# TEXAS A&M UNIVERSITY

ADDITIONAL INFORMATION CONCERNING  
TEXAS A&M UNIVERSITY, NUCLEAR SCIENCE CENTER REACTOR  
RADIOGRAPHY OF EXPLOSIVE MATERIAL  
REQUEST FOR TECHNICAL SPECIFICATION CHANGE

DOCKET NO. 50-128

FIG. 1 - RELATIONSHIP of N-RAD FACILITY  
to REACTOR SAFETY SYSTEMS

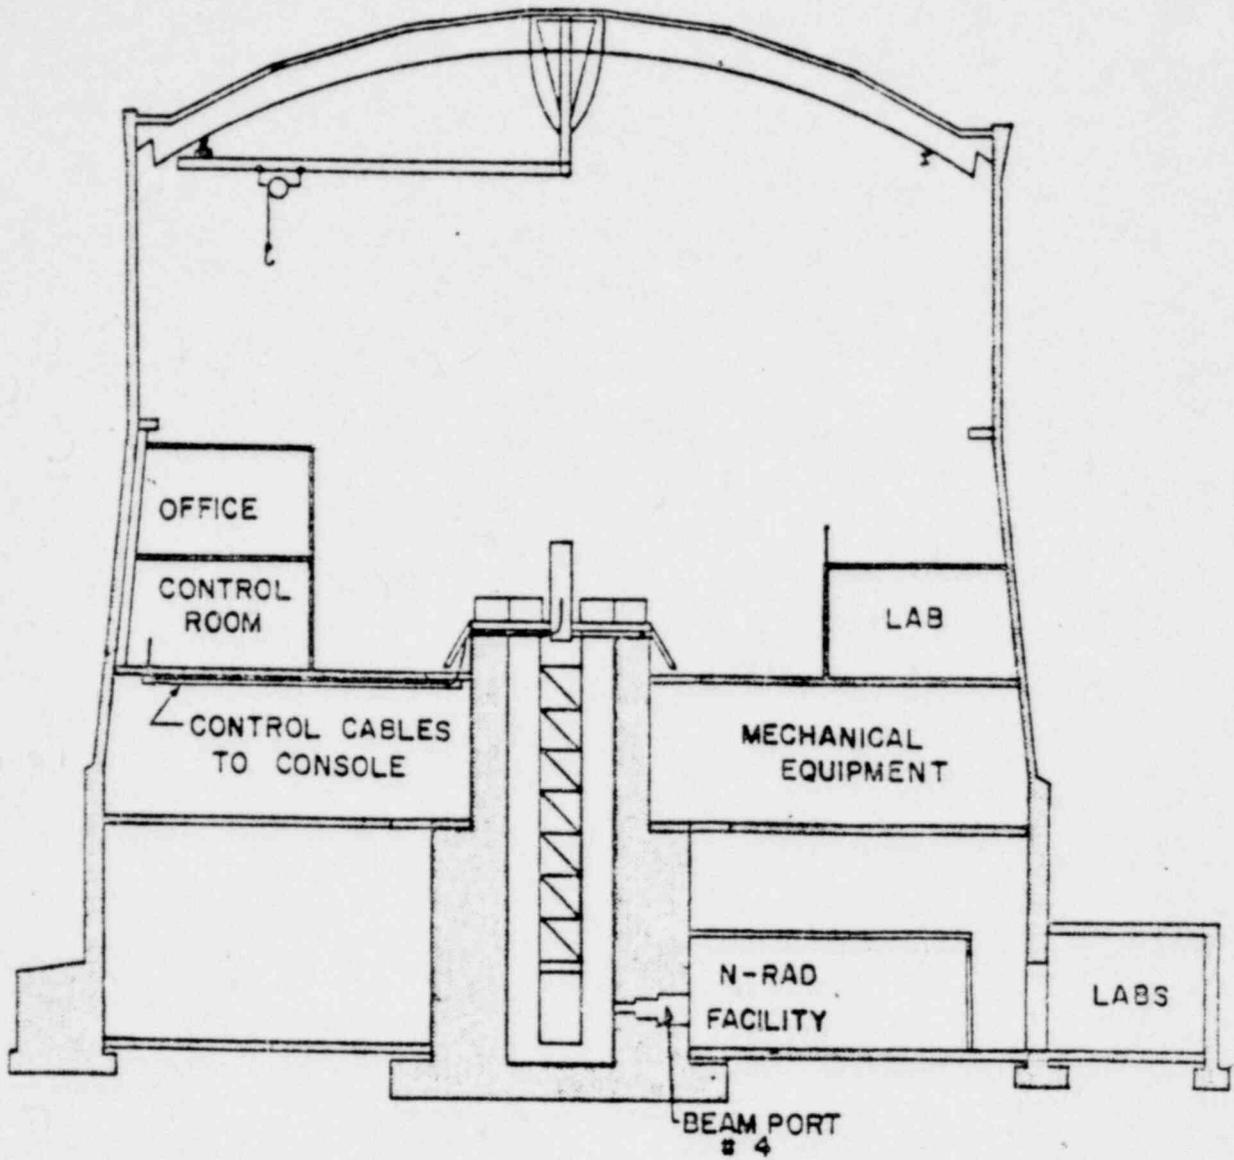
What effect would the detonation of an explosive charge and/or a fire in the neutron radiography facility have on the controls, electrical systems, and small components that are reactor safety related?

In evaluating the effect of a fire or an explosion in the neutron radiography facility, it is necessary to fully understand the location of that facility in the building relative to the reactor safety system. Figure 1 shows the section of the reactor building and pool through the radiography facility which is located on the lowest level of the reactor facility. The level above the radiography facility contains mechanical and electrical equipment. The floor is six inch thick reinforced concrete. There is another similar floor which defines the upper research level which is constructed of four inch thick reinforced concrete. The control room and all critical safety cables are located on the opposite side of the reactor pool so that it is completely shielded from any explosion that could occur in the neutron radiography facility. Even during transport of the explosives through the lower level of the reactor facility the control room is shielded by two reinforced concrete floors and the control cables by one floor. Since the radiography facility is constructed of some wood and paraffin, it is conceivable that an explosion or electrical short could cause these materials to burn. If this should happen these would be the only materials to burn since there are no other significant combustibles on the lower research level. All of the walls and floors and ceilings are concrete. The smoke and possibly some flames could pass through the air conditioning grates in the ceiling above the neutron radiography facility, but there is no safety reactor equipment located in that area. All that would happen would be some smoke deposition in the mechanical level of the reactor building. There is an experiment scram which allows the reactor to be shut down from the lower research level which could be damaged by a blast or fire. However, this would probably shut the reactor down since a scram is initiated if the circuit is opened. It is therefore concluded that an explosion and/or fire resulting in the complete consumption of combustibles in the radiography facility would not endanger the reactor or any of its support systems.
